ADDENDUM NO.1 - Mercedes Sports Park – Phase 1

DATE: Tuesday, December 11, 2018

JOB No. 2017-019

PHASE: 100% C.D.

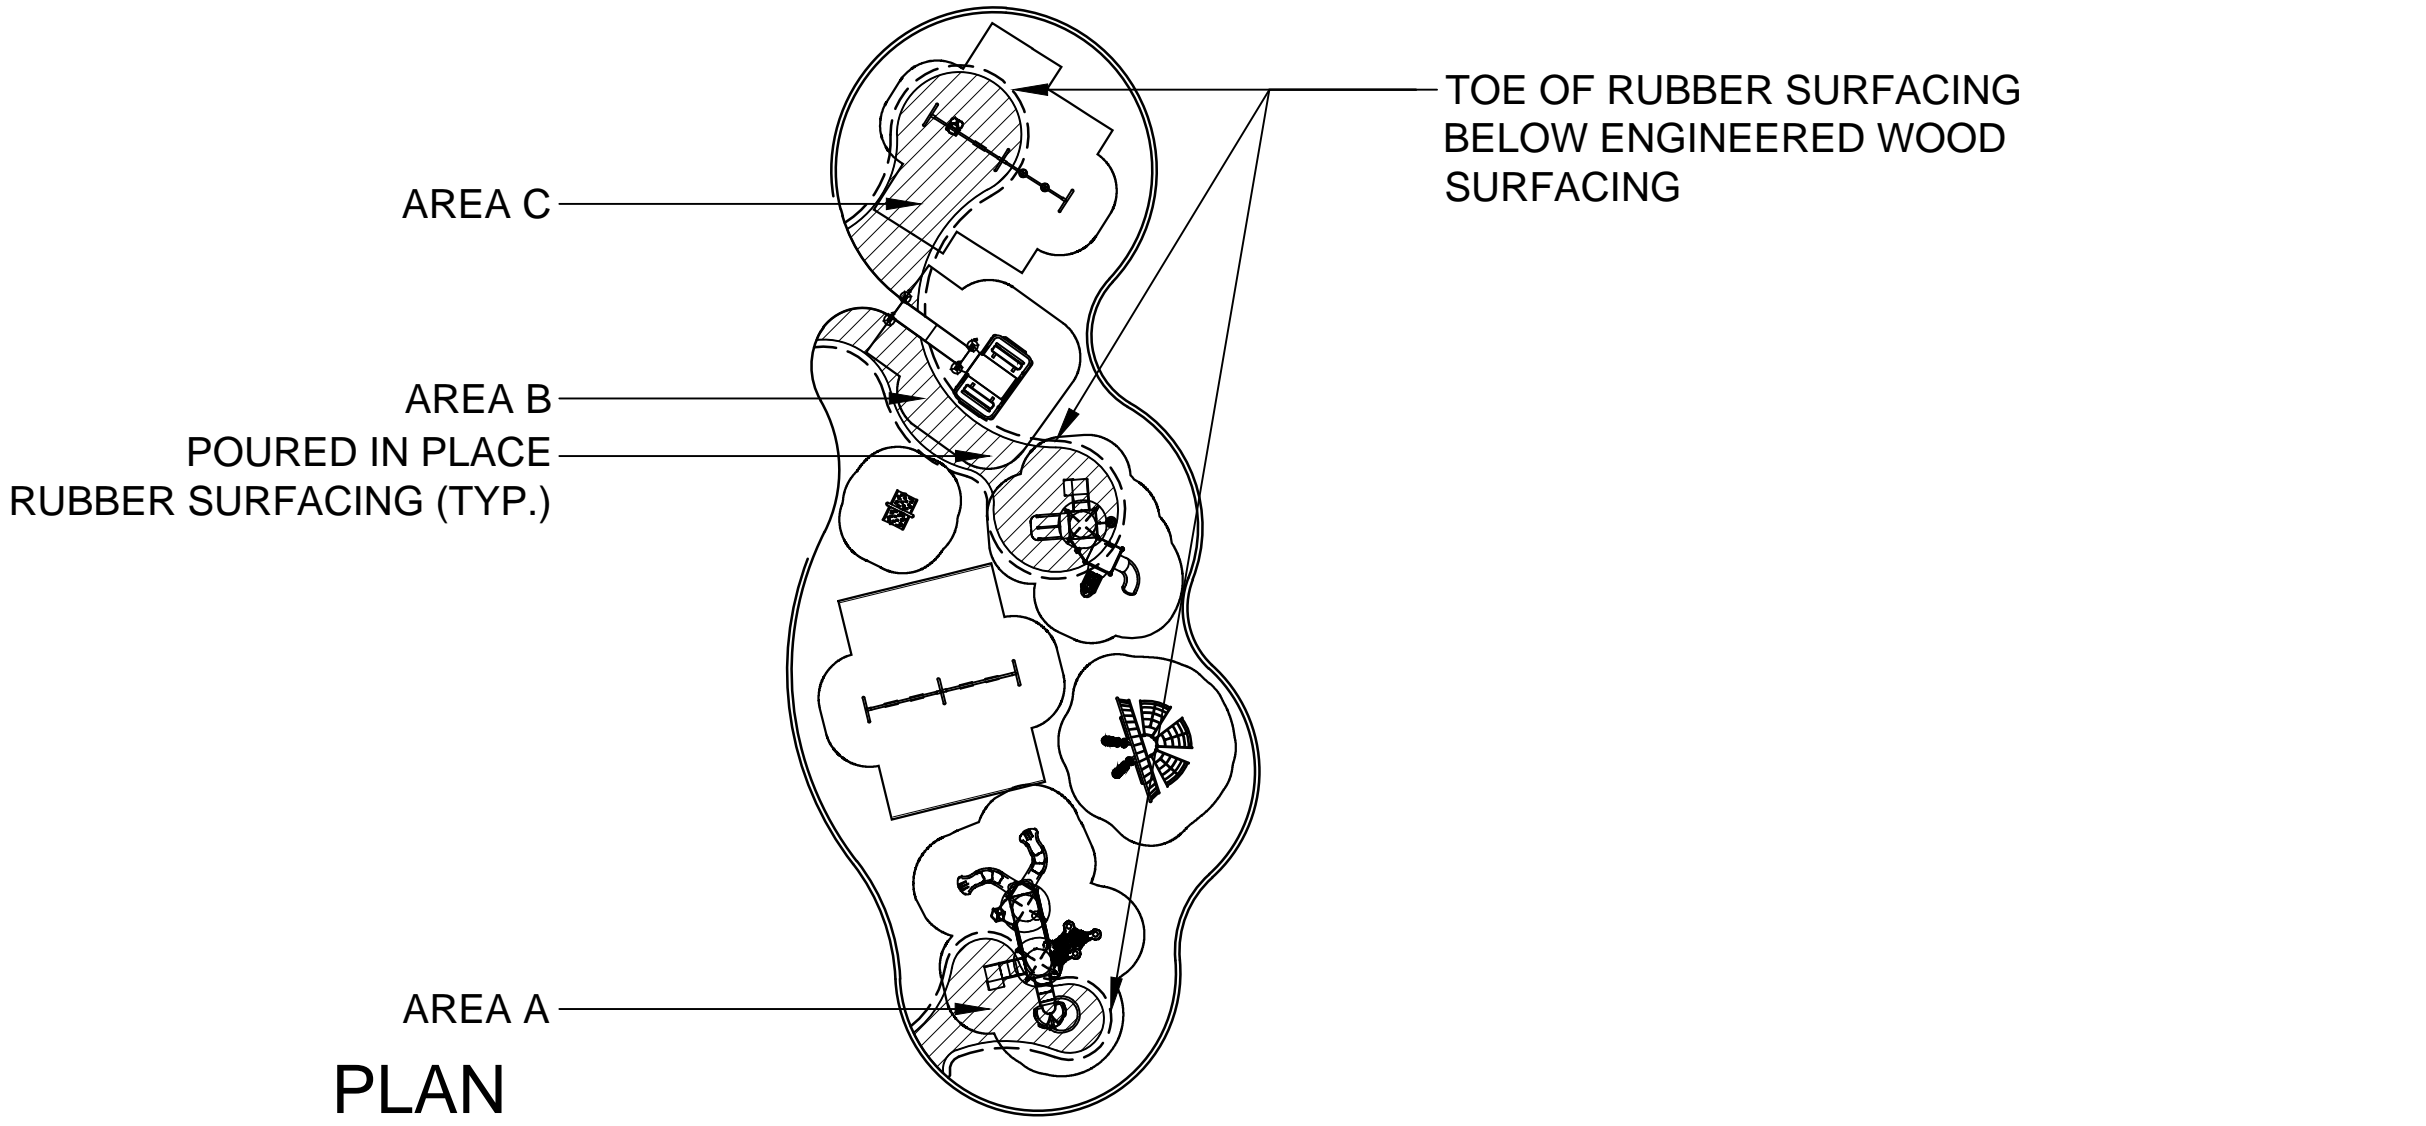
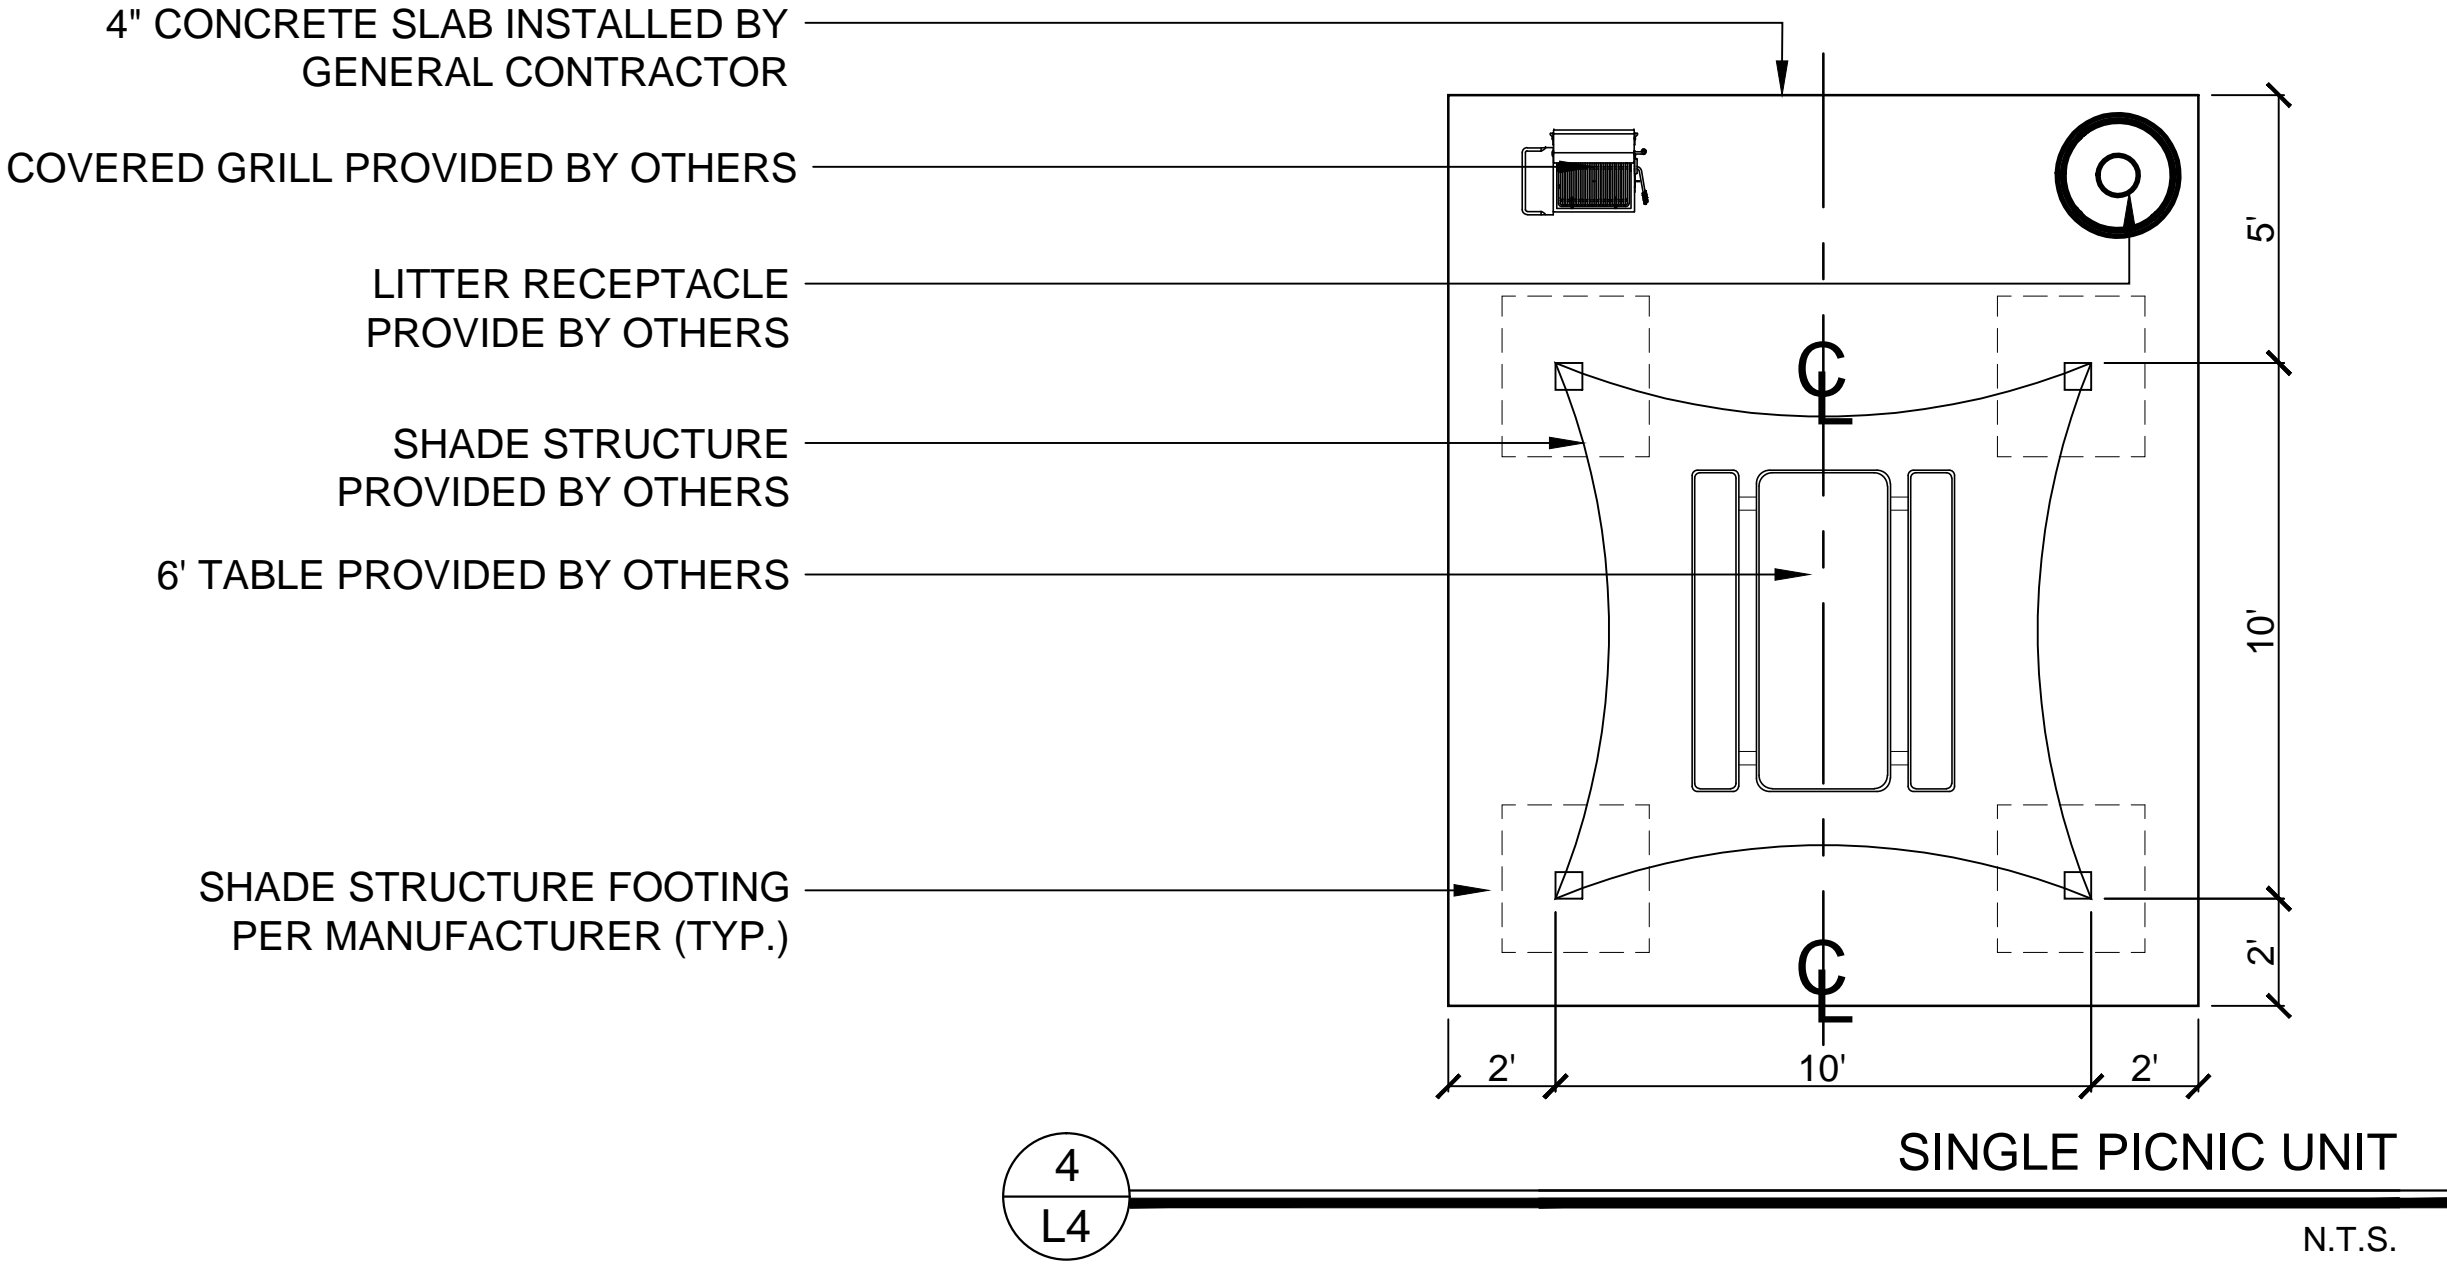
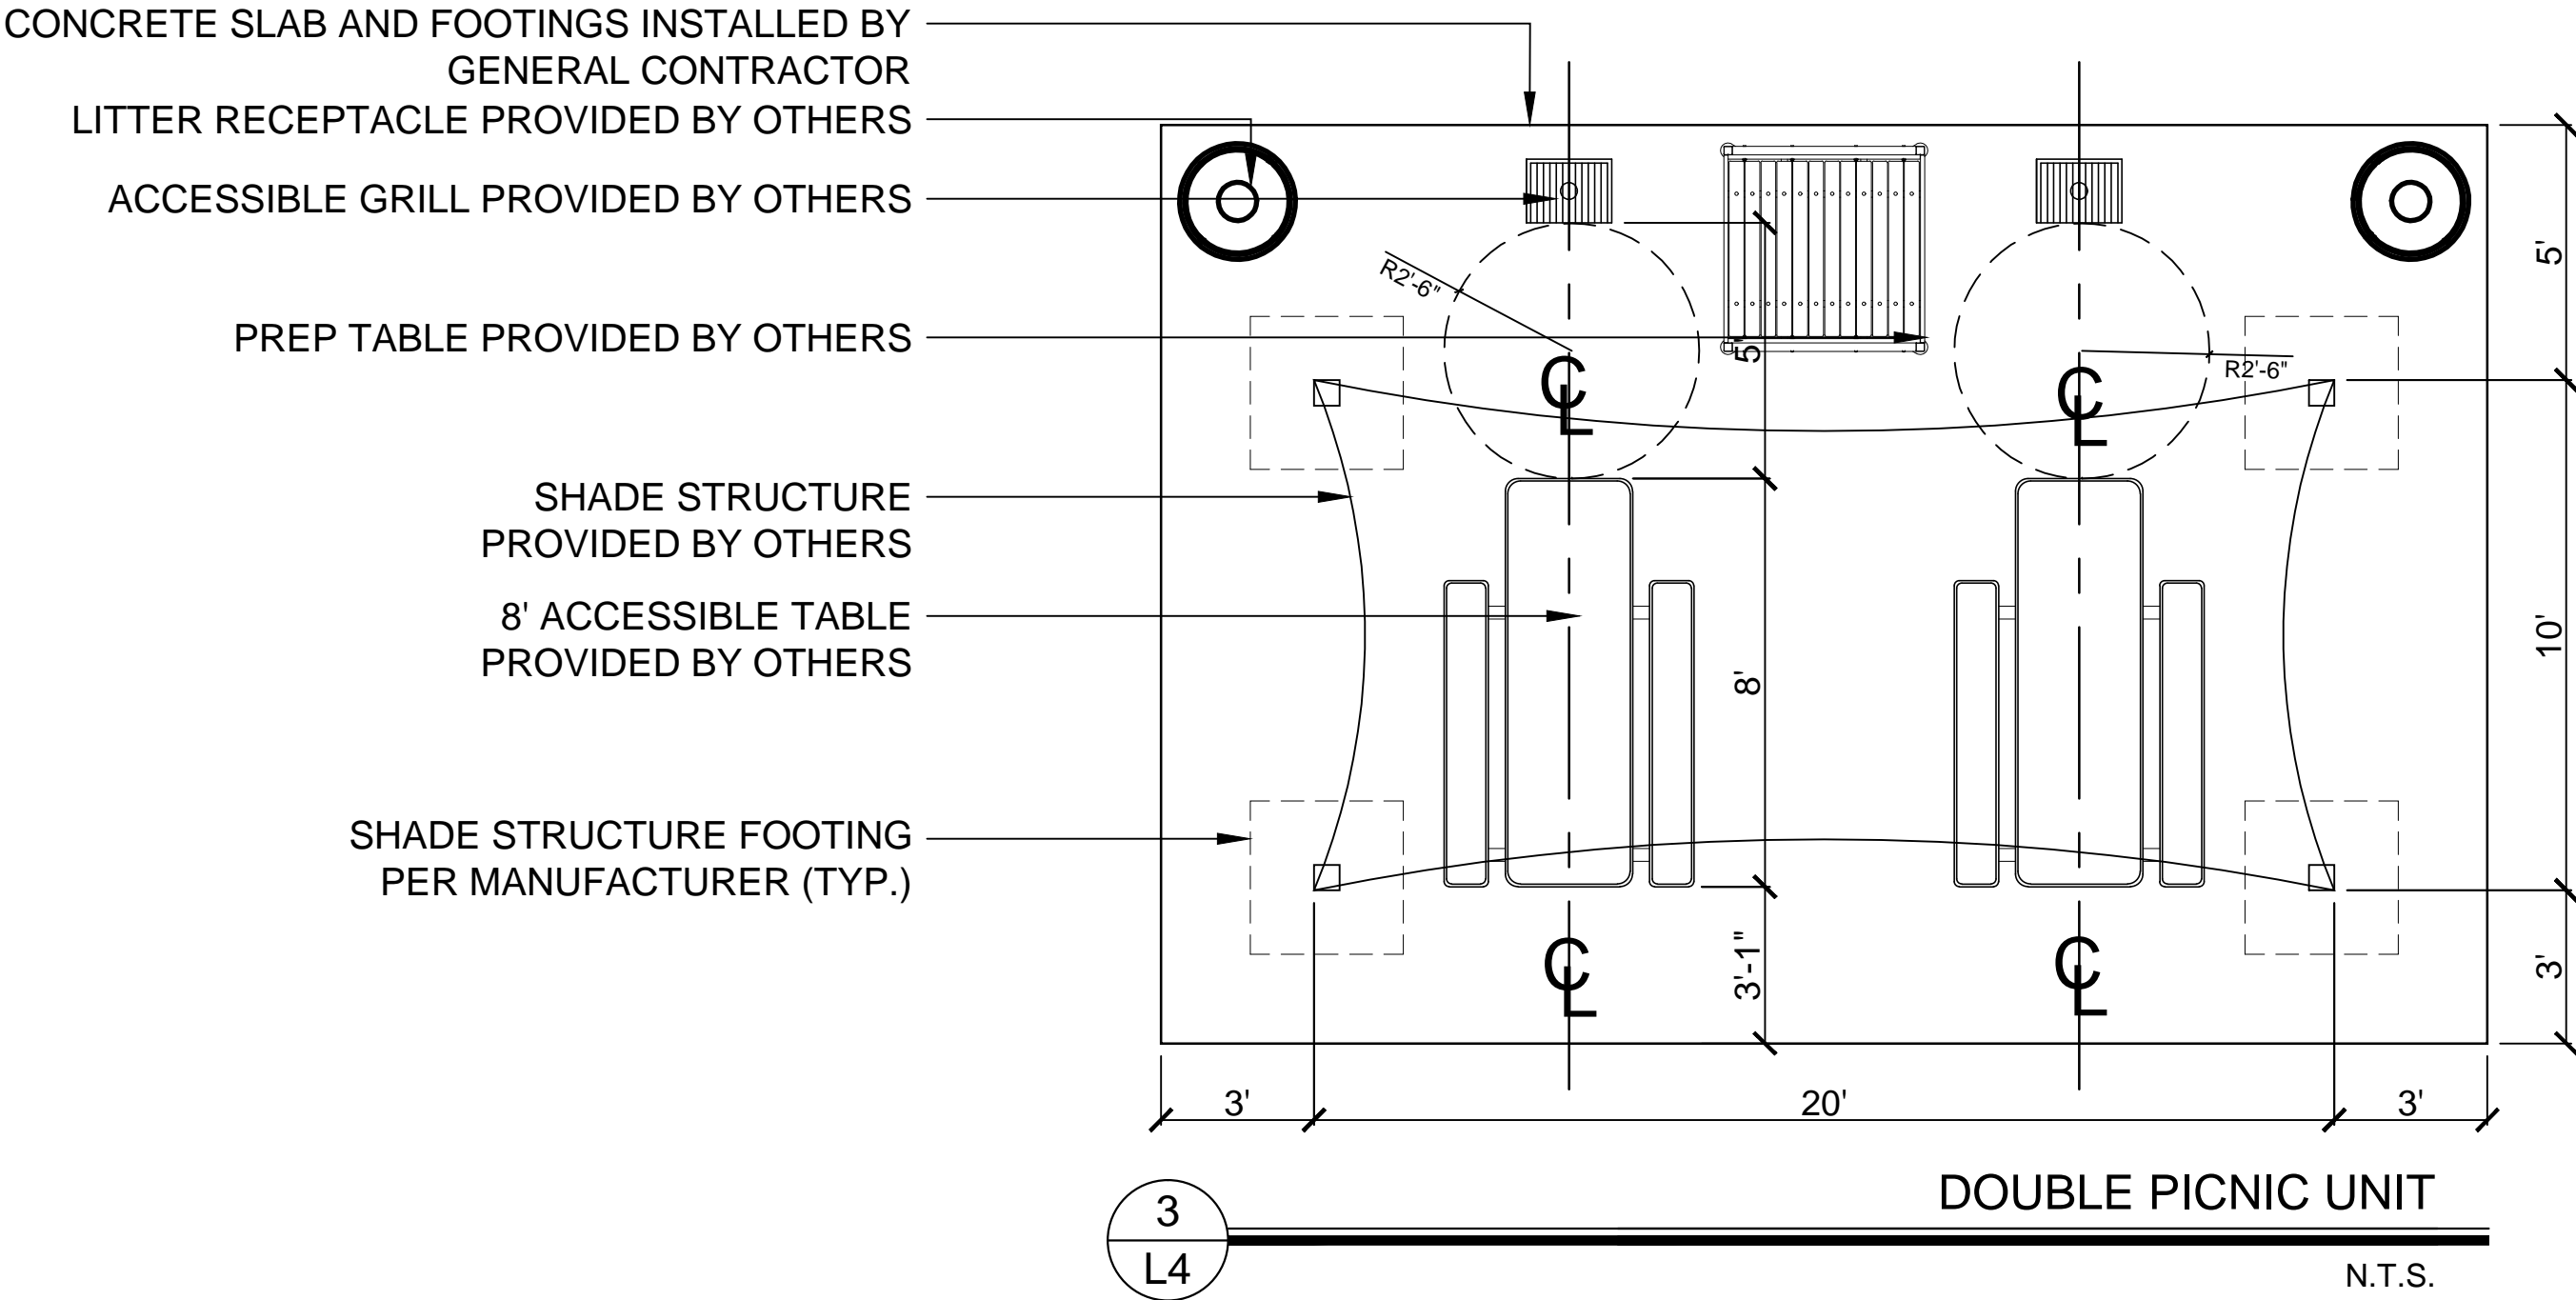
- A. See attached Landscape Addendum items. (12-8.5x11), (2-24"x36")
Sheet L2: Added a note for sidewalk intersections, this note will refer you to detail 6/L4.
Sheet L4: Added sidewalk intersection layout detail for control/expansion joints to reduce concrete cracking.
Per attached, add Specification Section 328400 NON-Potable Planting Irrigation. This Spec Section is for the harvesting tank irrigation system use only.
